PRODUCT CHANGE NOTICE

**Alternate Manufacturing Site
for Assembly of the Listed
Intersil QSOP and SC-70
Packaged Products**

**Refer to:
PCN12091**

Subject: **Alternate Manufacturing Site for Assembly of the Listed Intersil QSOP and SC-70 Packaged Products – Carsem, Ipoh Malaysia (CAM)**

PCN12091 – Current POD QSOP 16I and 24I

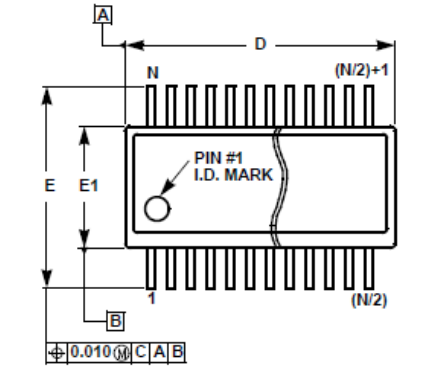
The Carsem (CAM) facility is ISO 9001:2008, TS 16949:2009, and ISO 14001:2004 certified. The CAM facility is qualified as a supplier to Intersil for performing assembly of packaged products, including the QSOP and SC-70 package styles. There will be no change in the die attach, bond wire (material or diameter), frame material, or moisture sensitivity level (MSL). The 16I QSOP, 24I QSOP, and select 6I SC-70 packaged devices will require minor dimension changes to the package outline drawings (POD). The affected PODs and a summary containing a list of products along with the current and new PODs are included for reference. The material set combinations for assembly and other key items are as follows:
